# C2M spec consistency and tolerancing

Piers Dawe

# 400GAUI-8 C2M issues

# Near and far end eyes, 2-tap FFE

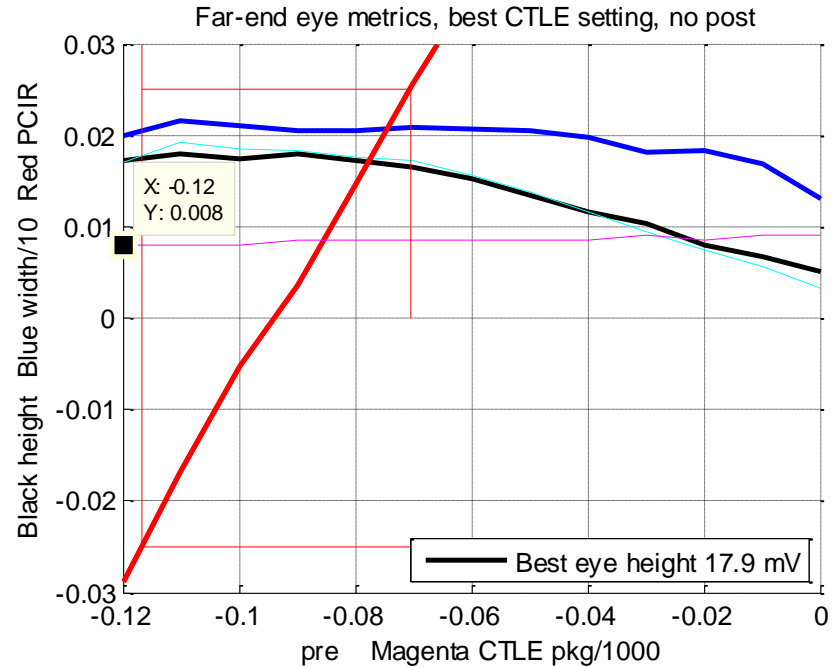
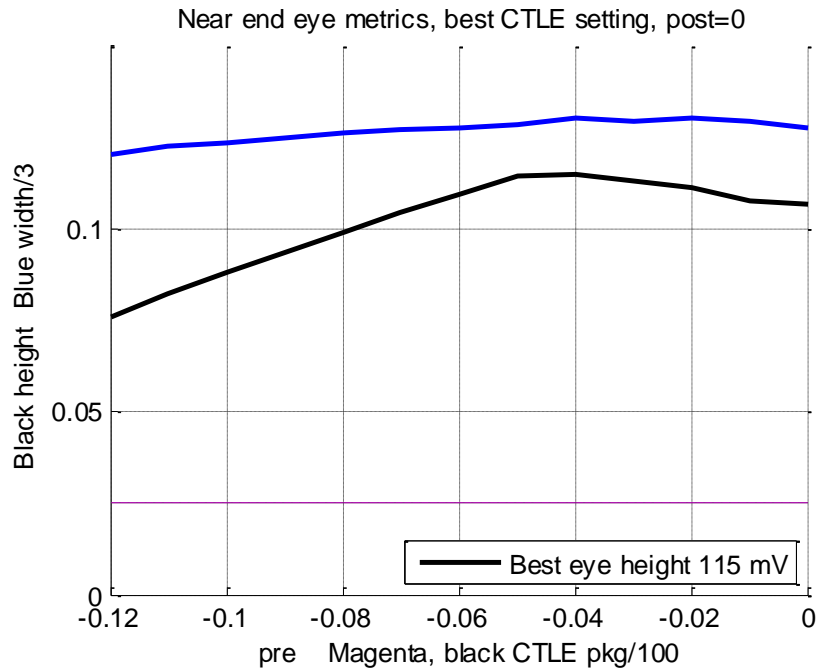
- With 2 dB extra "soft" channel loss. CTLE selected for best  $EH \cdot EW$ : 8 or 8.5 dB in the range between the red lines
- Eye heights and widths could be higher or lower than these
- Range of FFE precursor settings that satisfies far-end ISI pre-cursor ISI ratio rule is only 0.0463. This is less than the 0.05 step size for the C2C Tx emphasis control, without allowing anything for tolerancing
- The far-end ISI pre-cursor ISI ratio rule ( $\pm 2.5\%$ ) is too tight
